## Change Notice

PCN No: 129

Notice Type: Product Revision Change

Product Type: SL164

PCN 129 SL164

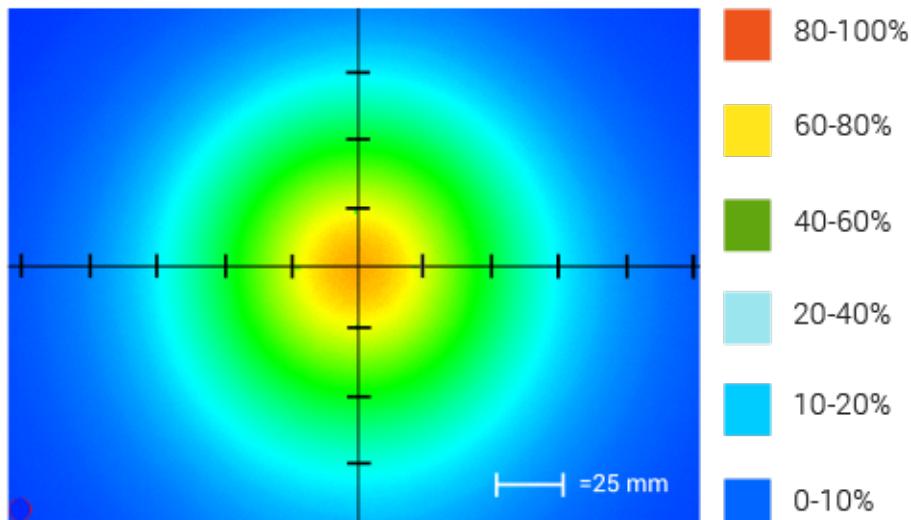
In an effort to improve our products, Advanced illumination (Ai) will update the LEDs used in the SL164 design. This change will result in a brighter, more uniform light at the same price\*. Customers may still buy the current revision of this model until July 15th of 2016. After that time, orders for these products will be converted to their respective SL164 Revision A models.

This LED change will result in additional wavelengths being available: 365nm, 375nm, 385nm, 395nm, 405nm, 455nm, 470nm, 505nm, 530nm, 590nm, 625nm, 660nm, 730nm, 850nm and 940nm. Additionally the white LED color temperature will be changing from 6100K to 5500K.

\*UV wavelengths (365nm, 375nm, 385nm, 395nm & 405nm) will be sold at a higher list price, which will be released at the time of product introduction.

Orders for customized (dash numbers) versions of SL164 will be honored until December 16th of 2016. Ai will be actively working with customers for those products to simplify the transition.
